Memorandum to the City of Markham Committee of Adjustment

A/06/18

Address: Applicant: 15 Wales Avenue, Markham Trina & Dimitrios Kollis

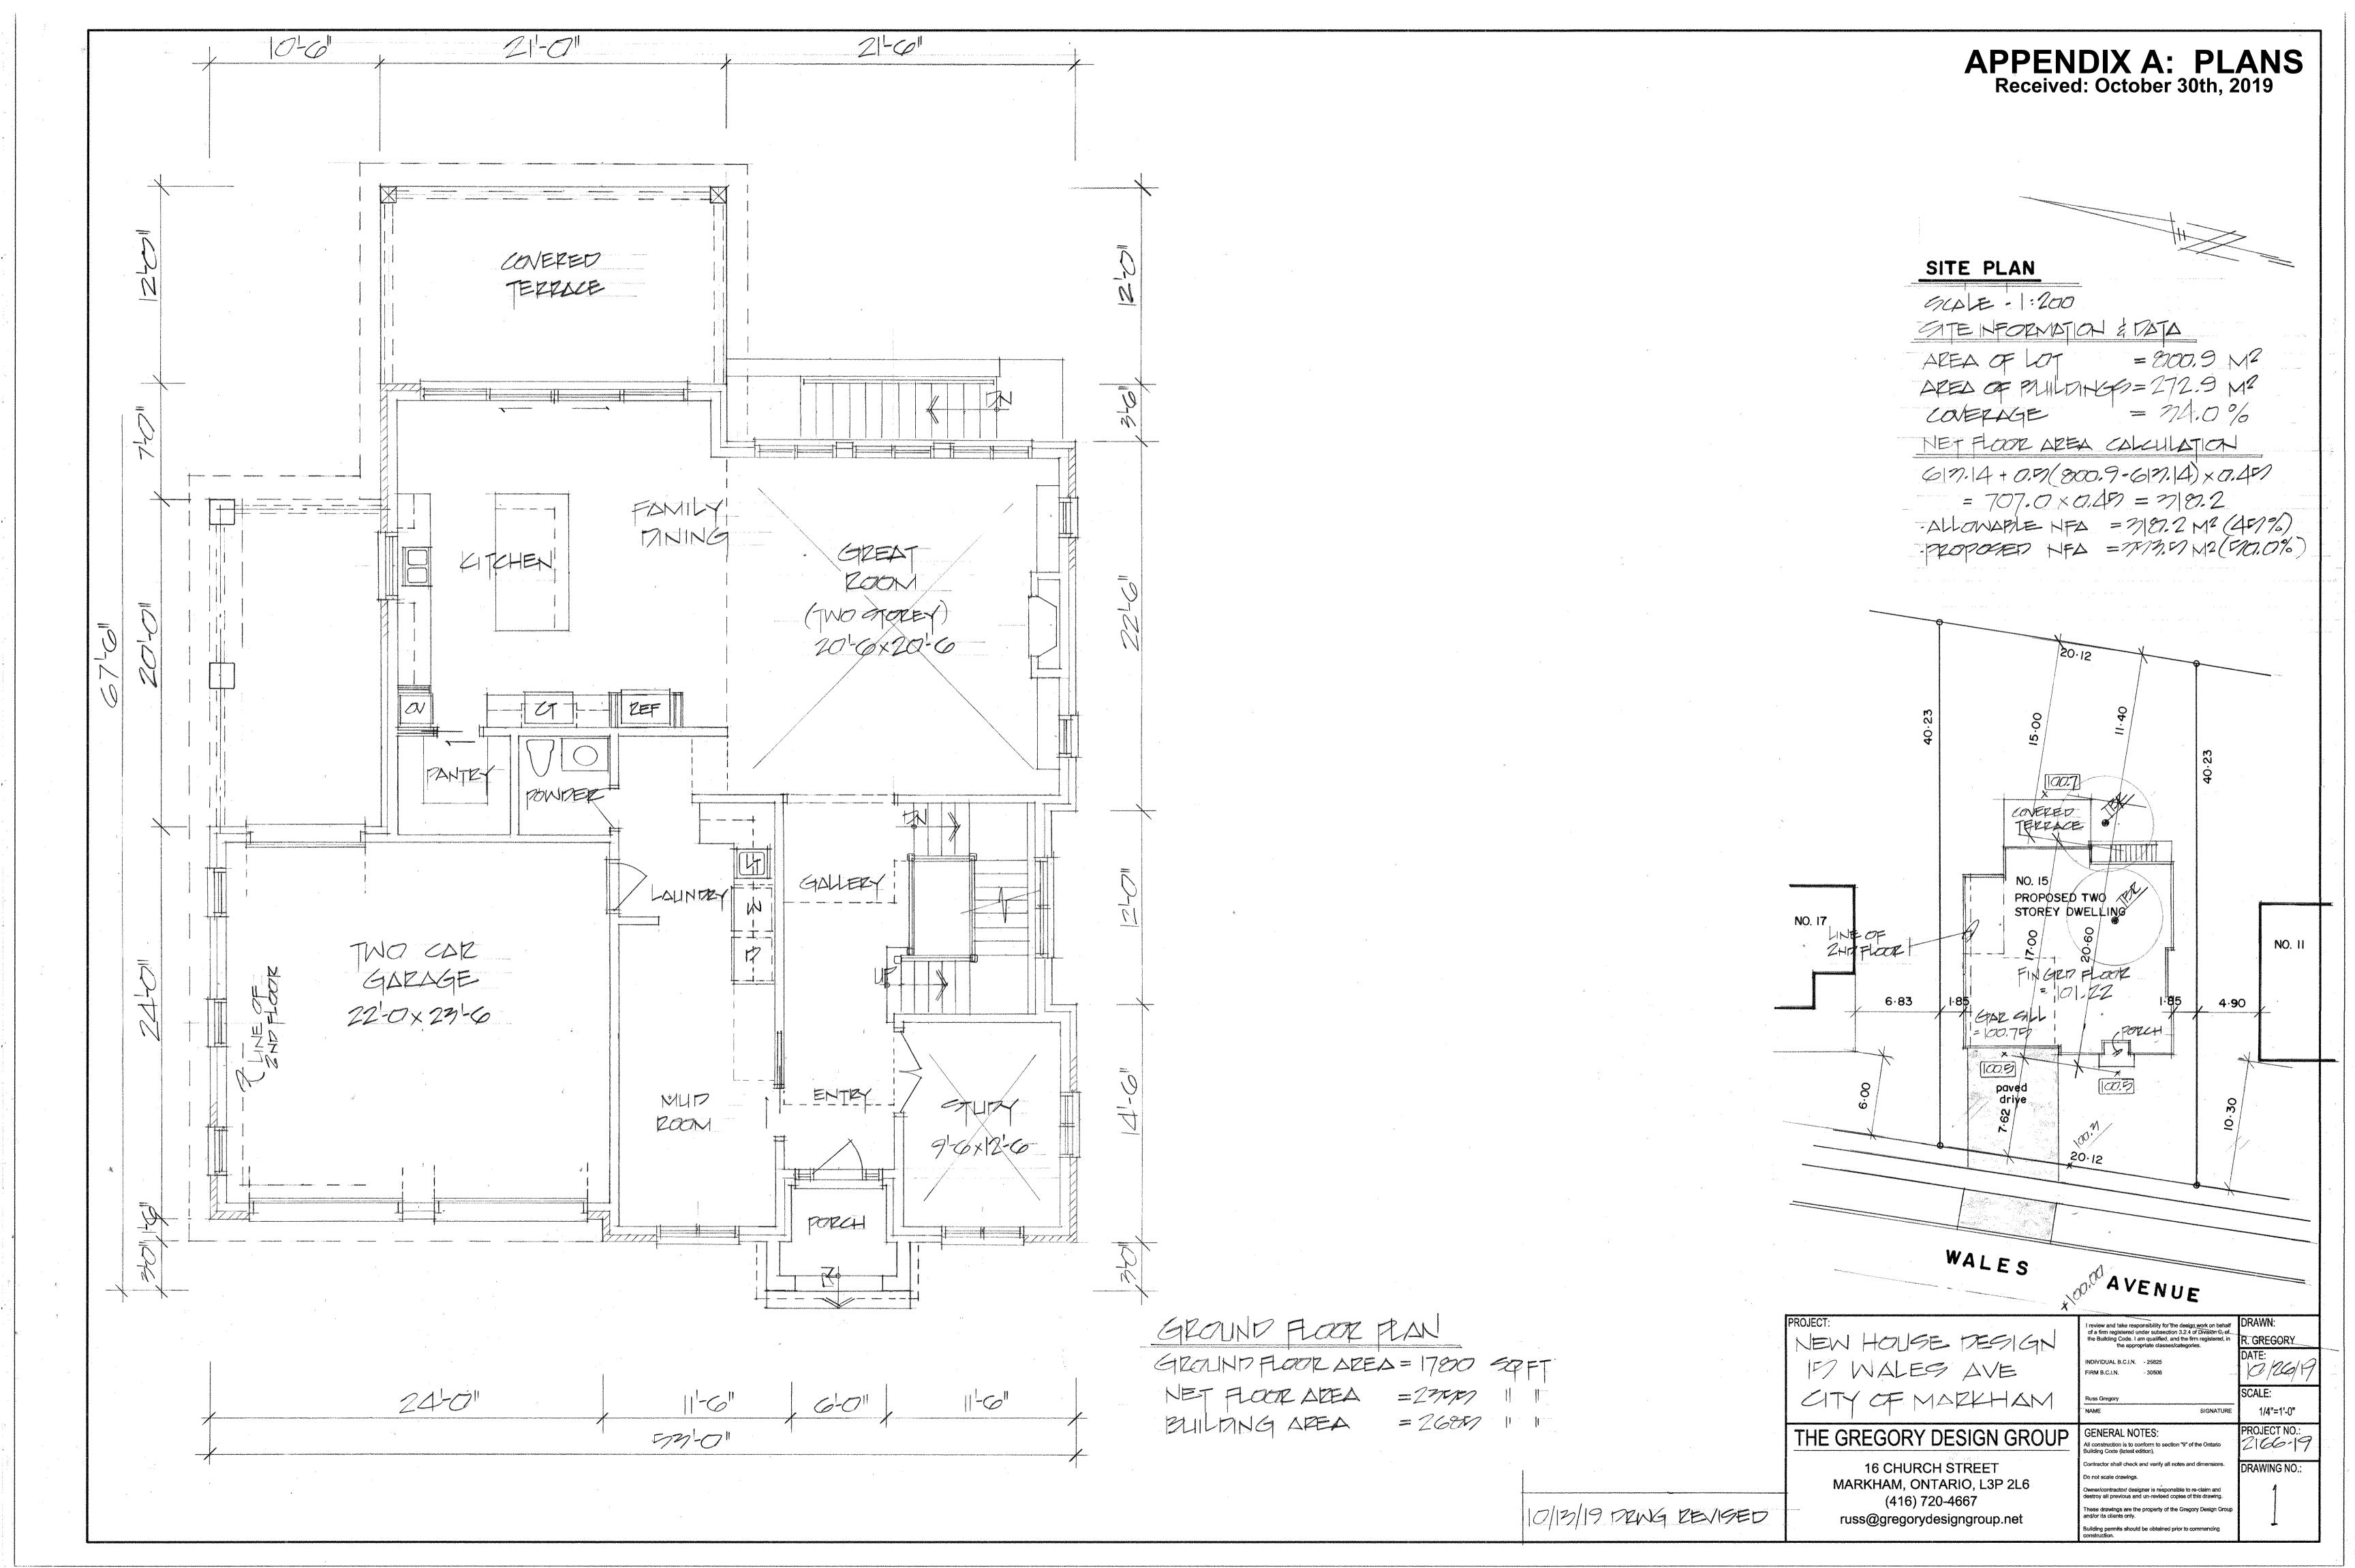
The applicant is requesting a maximum building depth of 20.6 m (67.58 ft), whereas the By-law permits a maximum building depth of 16.8 m (55.12 ft). This is an increase of approximately 3.8 m (12.46 ft).

Building depth is measured based on the shortest distance between two lines, both parallel to the front lot line, one passing though the point on the dwelling which is the nearest and the other through the point on the dwelling which is the farthest from the front lot line. Given the configuration of the lot, building depth is measured on an angle through the proposed building.

The proposed building depth includes a front covered porch and a rear covered terrace, which add approximately 0.91 m (3 ft) and 3.6 m (12 ft) respectively to the overall depth of the building. The main component of the building, excluding the porch and covered terrace, has a depth of 16.09 m (52.8 ft) which complies with the by-law requirement. Staff note that the previous submission presented to the Committee of Adjustment on September 25, 2019 did not include a covered terrace in the rear yard which is now being proposed. This has resulted in the proposed depth increasing from 17.5 m (57.41 ft) to 20.6 m (67.58 ft).

The applicant is requesting a floor area ratio of 50 percent, whereas the By-law permits a maximum floor area ratio of 45 percent. The variance will facilitate the construction of a two-storey detached dwelling with a floor area of 353.5 m² (3,805.04 ft²), whereas the By-law permits a dwelling with a maximum floor area of 318.2 m² (3,425.07 ft²). This is an increase of 35.3 m² (380 ft²).

The applicant has reduced their previous September 25, 2019 variance request of 51.8 % to 50%. The proposed dwelling still includes a 47.03 m² (506.22 ft²) 'open to below' area on the 2nd storey. While 'open to below' areas are excluded from the gross floor area calculation under the by-law, it still adds to the overall bulk and mass of the dwelling. With the exception to the requested building depth and floor area ratio variances, the proposed dwelling conforms to all other zoning provision including setbacks, lot coverage, and building height. Staff also note that this is the seventh time this application has presented to the Committee of Adjustment and the Committee should satisfy themselves as to whether the floor area ratio variance is appropriate.
